**Environmental permit application EPR/YP3735YK/A001**

**to drill at Leith Hill, Surrey:**

**Response to the Environment Agency in the context**

**of relevant geology and hydrogeology**

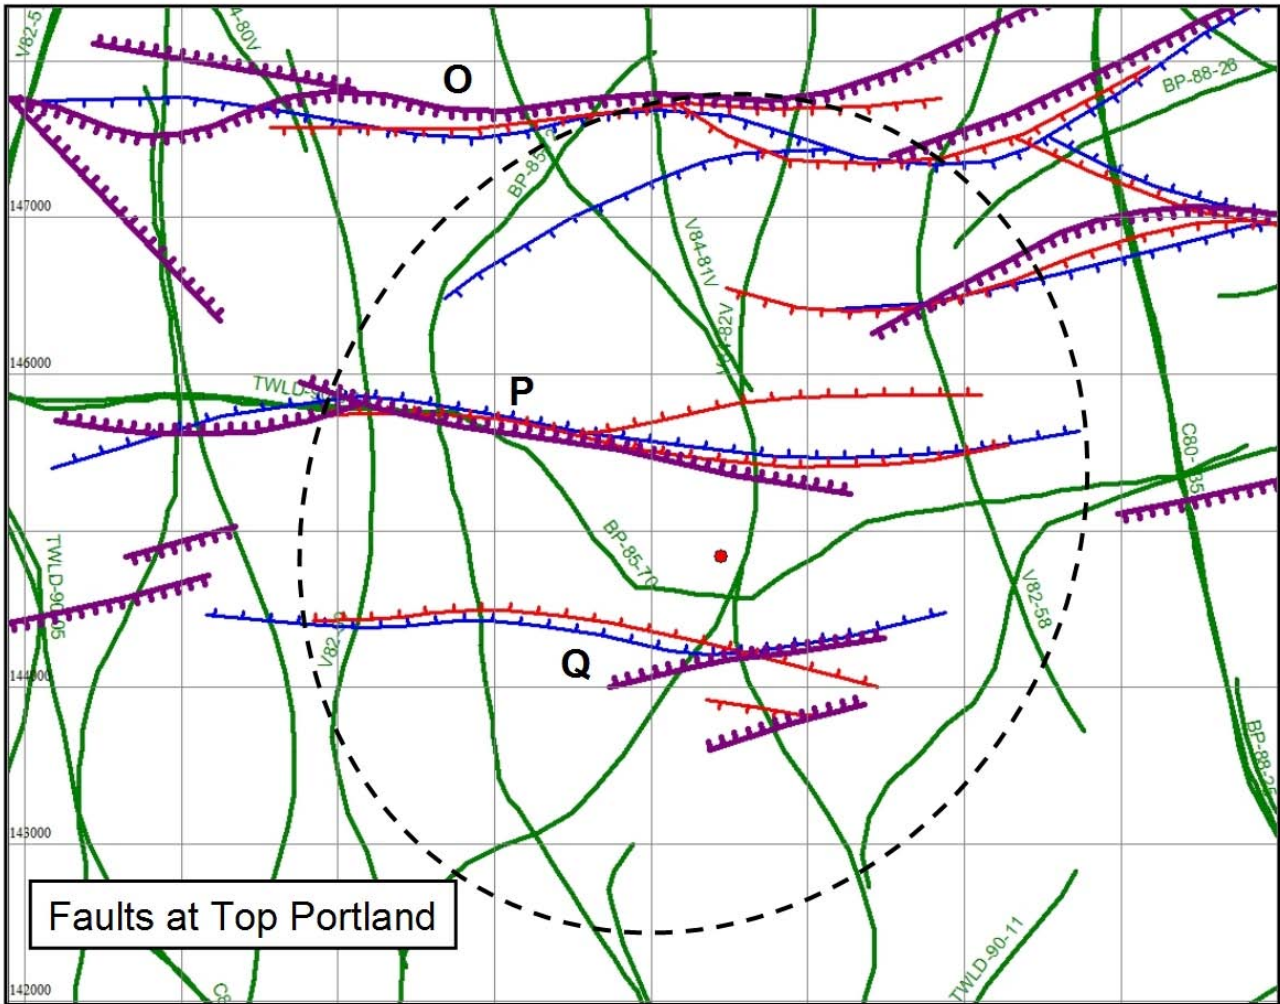
The reasonably robust closure mapped by BP lies south of fault zone P and encompasses fault zone Q, where, in contrast to later interpretations, BP mapped only two minor faults trending ENE-WSW. The main closure mapped by Teredo resembles the Holmwood South prospect mapped by the Applicant in 2004, but is offset to the north by about 1 km. There are no public data to enable a determination of whether Europa's 490 ms contour (Figure 2.3) east of the wellsite, near seismic line V82-58, is robust, or else has been optimistically closed off.

The attempts to map a closure between fault zones O and P (Figure 2.5) have been unsuccessful, or have resulted in only very minor closures. Europa's North Holmwood Top Portland prospect depends upon sealing on the downthrown side of fault zone O. However, there may be some validity in a deeper target such as the Corallian straddling the central fault zone P as a valid but

Figure 3.2. Seismic tie from Collendean Farm-1 along seismic lines C80-130, TWLD-90-04 and V81-53 to Holmwood-1 (proposed).

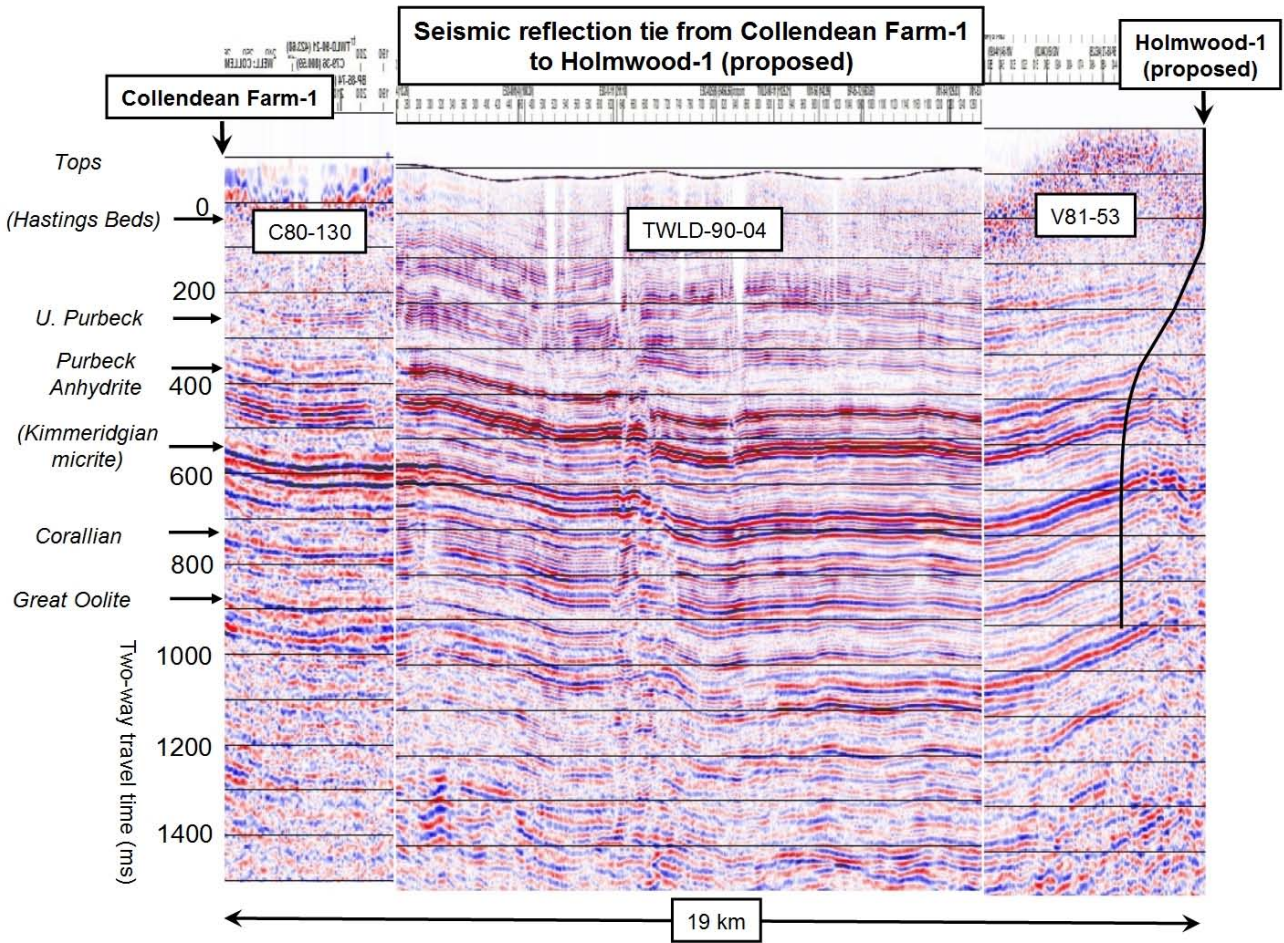
I have added the two horizon two-way times shown in brackets at Collendean Farm-1, by interpolation. The Hastings Beds tie is approximate, as can be seen by the poor quality of the shallow seismic data on C80-130, but lies just above the better-quality high-frequency reflectors

It can be seen in Figure 3.2 that the three seismic panels have been offset slightly relative to each other in a vertical sense to enable a visual match of the reflectors. This correction has been applied because the different vintages of seismic survey have different static corrections applied. Within any one survey, that is to say, the set of seismic lines surveyed and processed by one company during a particular campaign, the static corrections will be consistent. However, with different methods of acquisition and processing across several different surveys, the final corrections (normally referred to sea level as the datum) are often different. The application of correct statics to each separate survey, to make them match up, is labour-intensive but crucial. There is no evidence that the Applicant has carried out this work.

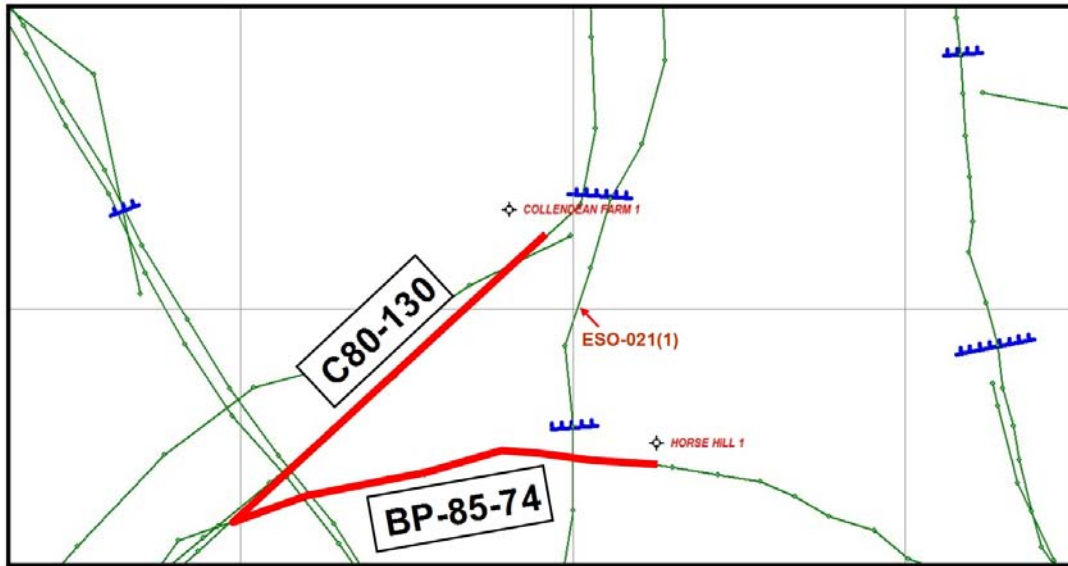
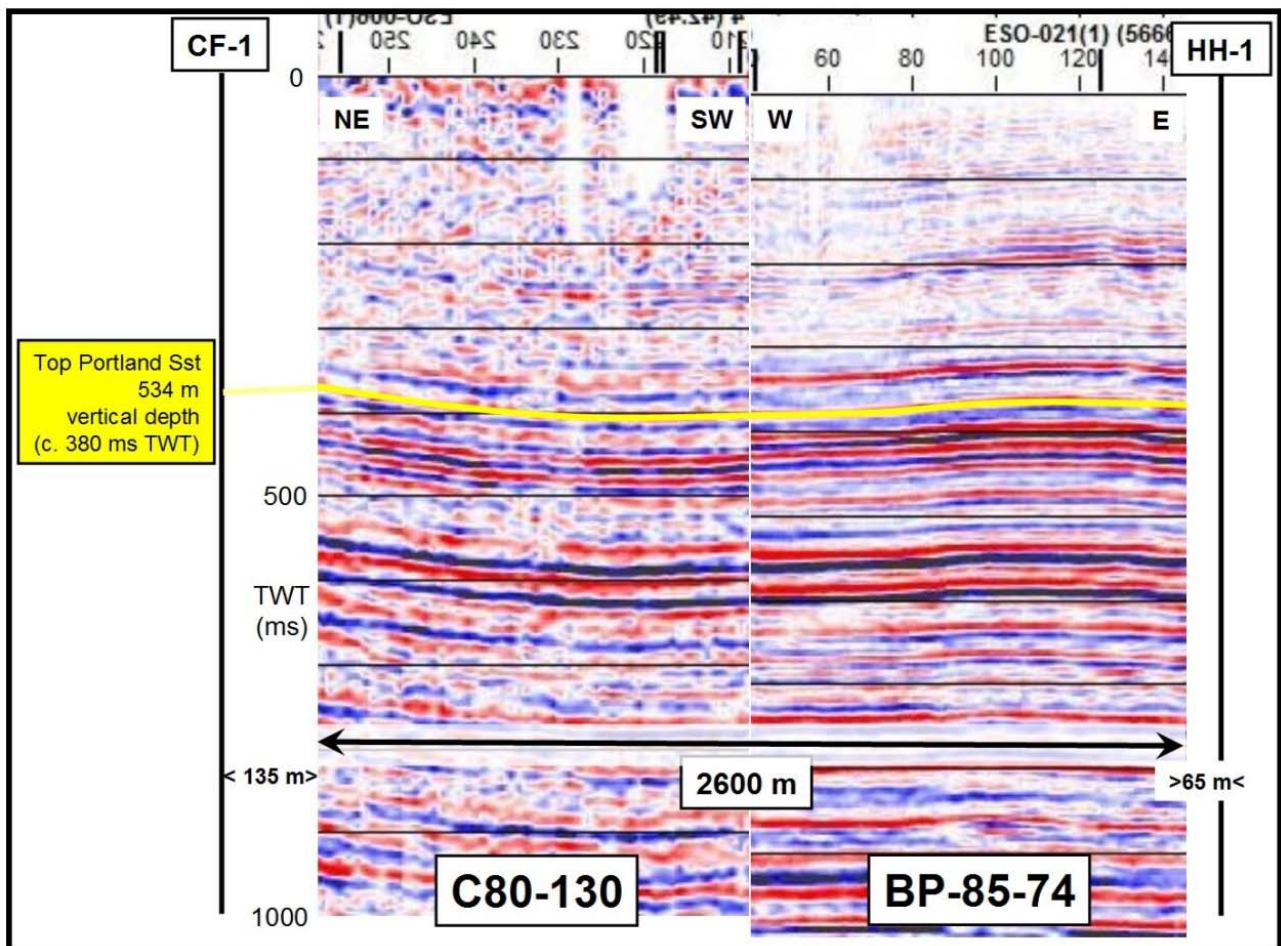
Here there has been a severe misinterpretation of the data both before and after drilling of the latter well by the Applicant's partner at Holmwood-1, UK Oil and Gas Limited (UKOG). So it is not clear whether the Applicant has simply taken the UKOG interpretation on trust, or else has made its own interpretation. The seismic tie between the two wells is simple (Figure 3.4), but requires a relative static correction of +25 ms to be applied to the BP line.

Has this correction (and other similar necessary adjustments) been applied around the Horse Hill / Collendean Farm area by the Applicant, before tying further west to Holmwood? No evidence has been furnished to the EA to suggest that this work has been done.

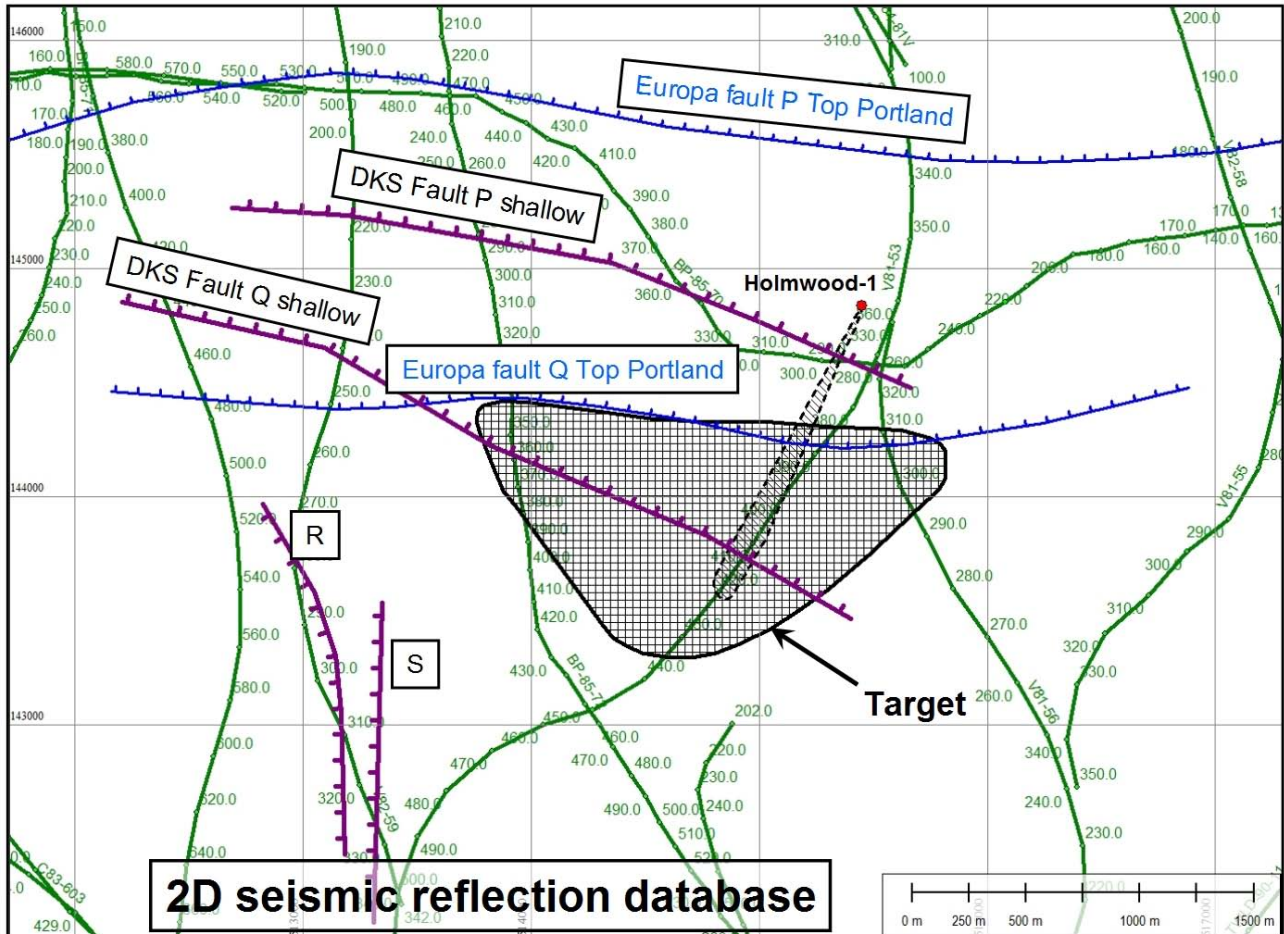
My version of the two main faults P and Q (see Figure 2.5 above) is shown in Figure 4.1 by purple lines. My fault P at shallow depth probably corresponds to Europa's fault P at Top Portland level; it is mapped further south than the latter because of the northerly dip of the fault plane. In contrast, my version of fault Q runs at an angle of about 30° to the east-west trend of Europa's fault Q. Recall also that BP's version of the faults at Q (Figure 2.1) trend towards the ENE, i.e. different again.

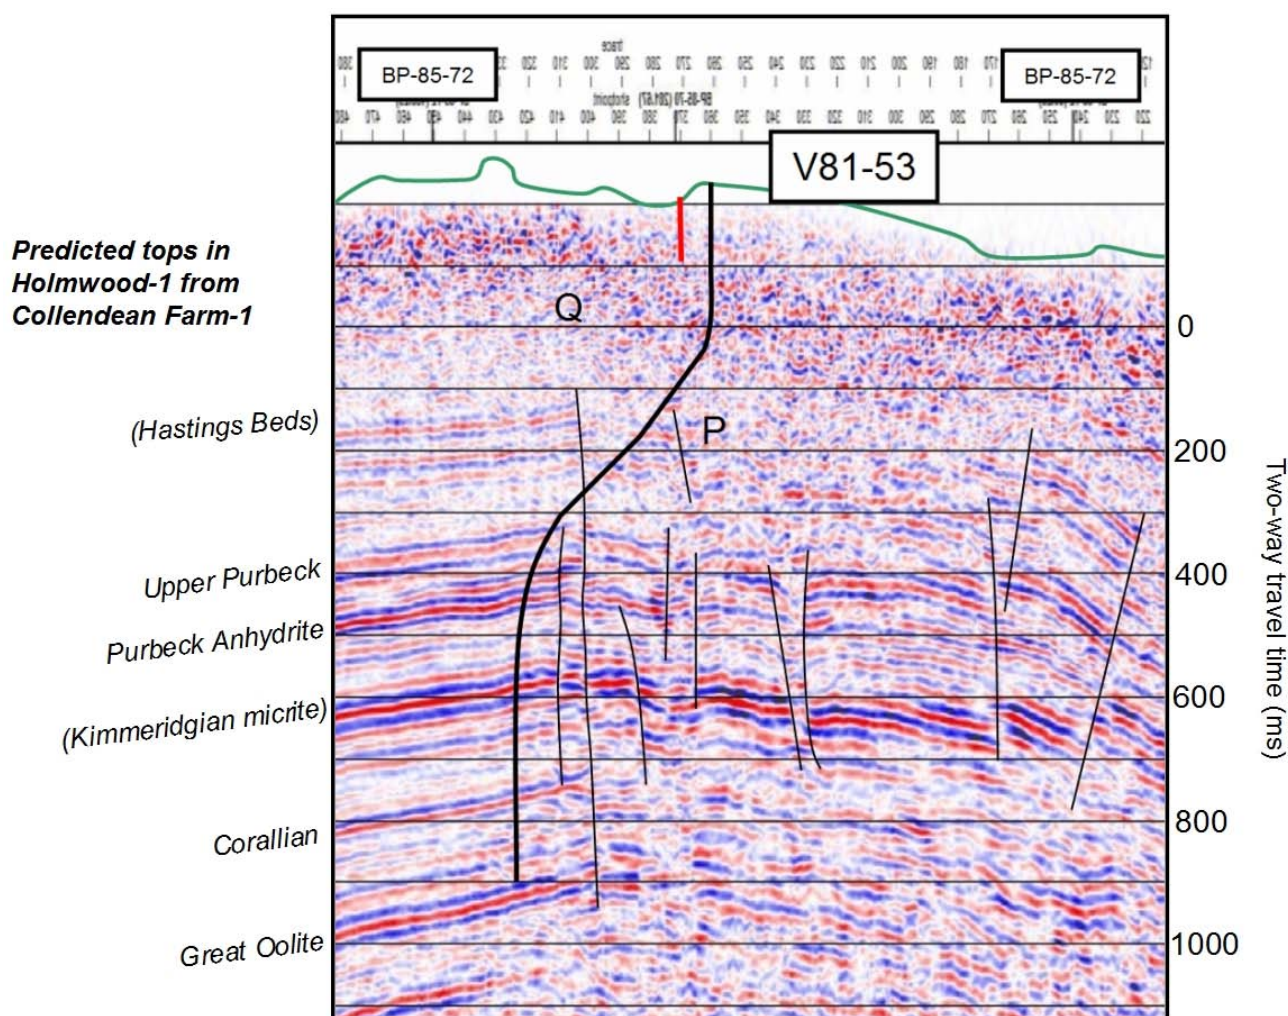
The wellbore trajectory is shown by the Z-shaped path; the exact shape of the bend is approximate, because I do not have access to an accurate time-depth conversion; however, the initial and final points are accurate. The vertical red line at the top just south of the wellbore is a

Figure 4.3. Revised well trajectory (black line) and revised horizon tops (coloured dashed lines, labelled), superimposed upon the Applicant's previous version (2015) of the geology. The approximate positions at shallow depth of faults P and Q from Figure 4.2 are marked by labels in purple boxes.

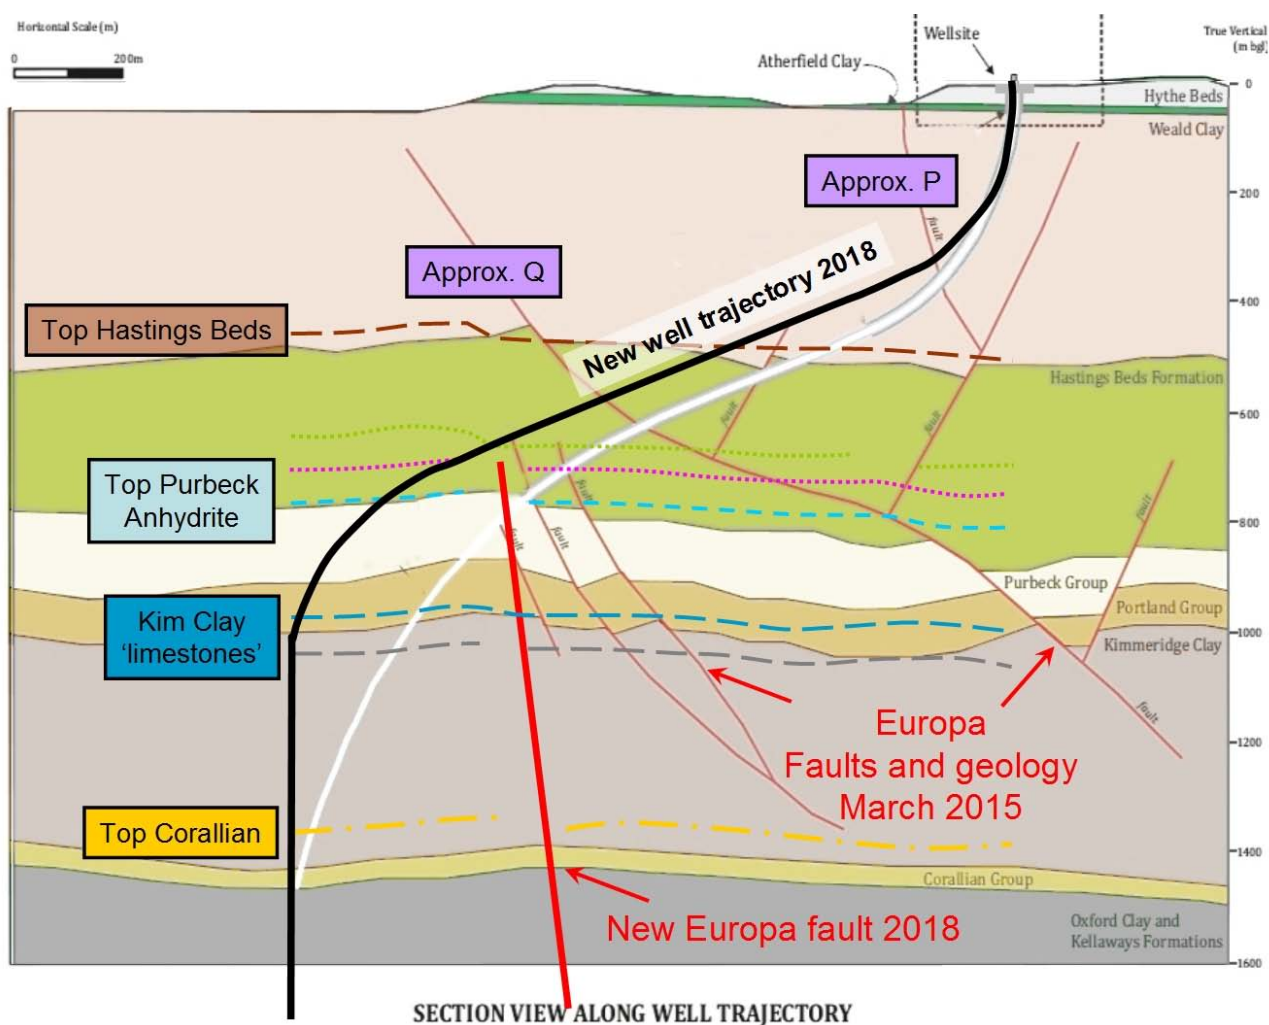
The new position of a fault (bold red line in Figure 4.3) has necessitated the upward shift of the deviated portion of the wellbore from that shown in white. In addition the Applicant has designed the wellbore to intersect the Top Purbeck Anhydrite just south of the new fault.

Firstly, it appears that almost all of the faults from 2015 (thin red lines in Figure 4.3) have now been discarded, as shown by the fact that the revised tops now run across the cross-section with no offsets. This suggests that the Applicant's interpretation of the geology was unsound in 2015, and there is no reason to suggest that it is any more sound now.

Secondly, the Applicant's new fault corresponds to my location for fault Q, as can be seen by comparison of Figures 4.2 and 4.3. However, in my interpretation it continues upwards to cut the Top Hastings Beds (Figure 4.3) where the Applicant indicates merely a small monoclinial feature in that horizon at around 420 m bgl. So this fault cuts through the geology at a crucial location in the cross-section, some 50 m north of the 'design point' of the wellbore, and where the inclination of the wellbore is running at what the Applicant concedes to be at the limit of its technical capacity. The limits of the new wellbore design have been pointed out independently in the hydrogeological review by EGG (2018).

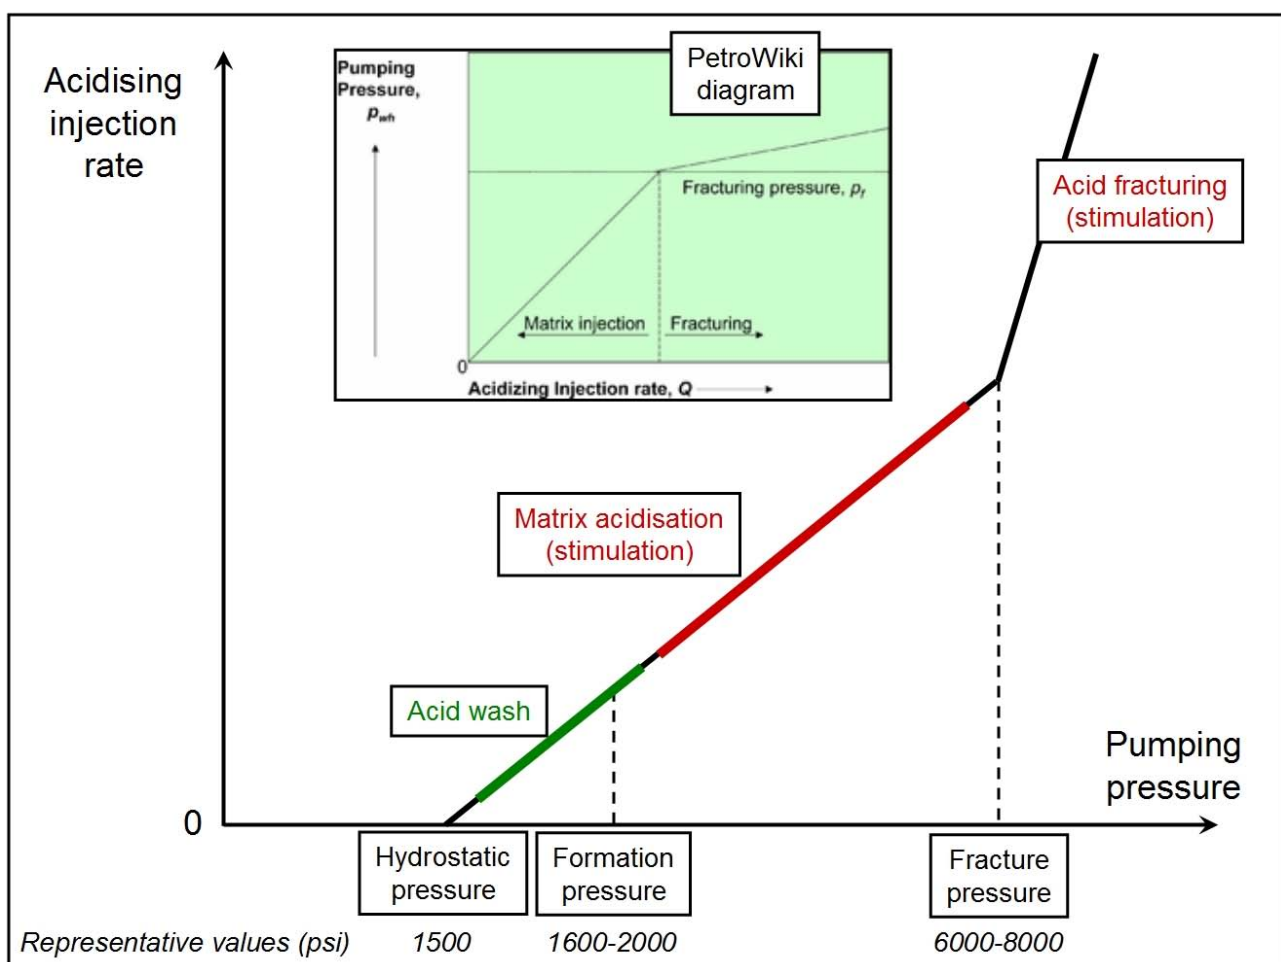
The PetroWiki axes are the wrong way round, because the injection rate depends on the pumping pressure; also, the line in the original graph goes through the origin, implying that any finite

pumping pressure will result in a flow. This is clearly not the case, because there will be no flow until the hydrostatic pressure at the injection point is exceeded. The graph ordinate of zero is perhaps intended to be the hydrostatic pressure at the formation depth, but this is not made explicit. Therefore in the modified graph I have put the dependent variable (rate of injection) as the vertical axis. The hydrostatic pressure, or 'normal' pressure, is the pressure due to an equivalent column of slightly saline water. The linear graph intersects the pumping pressure axis at a finite positive value, the hydrostatic pressure. Below that pressure there will be no injection.

The zone of matrix acidisation is shown by the red line in Figure 5.1. In practice this may overlap with the green zone. Now the intent of the Applicant's use of matrix acidisation is stated to be merely for cleaning up damage, and not for enhancing permeability, but how can we differentiate between the two actions? We can further ask, why is there a need for the so-called 'acid squeeze' at all? The only feasible solution to this problem, to ensure that the Applicant does limit its activity to near-wellbore damage repair, is to limit the permitted volume and concentration of HCl to values that will suffice for cleaning. The figures for the volumes and strengths of acid allegedly required appear to differ greatly between the original and the revised application. These discrepancies have been discussed in a separate consultation submission by Ms Adriana Zalucka, which I include herein as Appendix A. Her submission refers to a California Department of Conservation (2014) discussion paper on the calculation of the acid volume threshold, to which I now refer.
